E8663D-06A

## E8663D Analog Signal Generator

Instrument failing self test 300 with E4423-60018 Ref Board

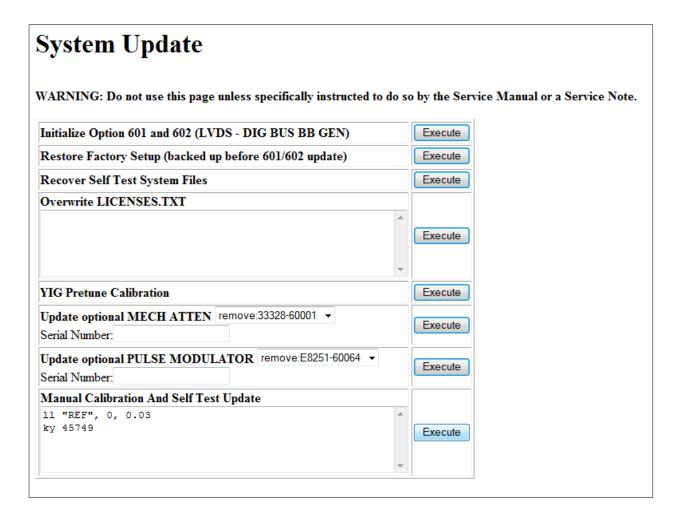
Instrument that has the current Output board replaced to E8251-60075 which then required a firmware upgrade to at least FW 06.XX would then fail self-test 300.

- 1. If you are experiencing self-test failure 300, verify the self-test limits by pressing: Utility > Instrument Information/Help Mode > Self Test > View Test Info.

- 2. Using the RPG or the up and down arrow keys, scroll to self-test 300. Press: Run Highlighted Test.
- 3. When the self-test has completed, press: View Details. The lower limit for the test should be 0.03.

- 4. If the lower self-test limit is correct, continue to troubleshoot the problem using the troubleshooting procedure. If the lower self-test limit is incorrect, proceed to step (5).

- 5. Connect the instrument to LAN, then press: Utility > GPIB/RS-232 LAN > LAN Setup > LAN Config set to DHCP > Proceed with Reconfiguration > Confirm Change (Instrument will Reboot).

- 6. After the instrument had power cycle, press: Utility > GPIB/RS-232 LAN > LAN Setup and record down the IP address.
- 7. Open a browser window and type in the instrument IP address/update (http://xxx.xxx.xxx.xxx/update)

- 8. Then, copy and paste the scrip below into the 'Manual Calibration And Self Test Update' box.

II "REF", 0, 0.03 ky 9051 Page 3 of 3 E8663D-06A

- 9. Press 'Execute' button next to the 'Manual Calibration And Self Test Update'.
- 10. When the update is completed, another webpage will be displayed with the message 'Operation completed'. To finish, power cycle the instrument and verify the limits have been updated using steps 1-3 above.
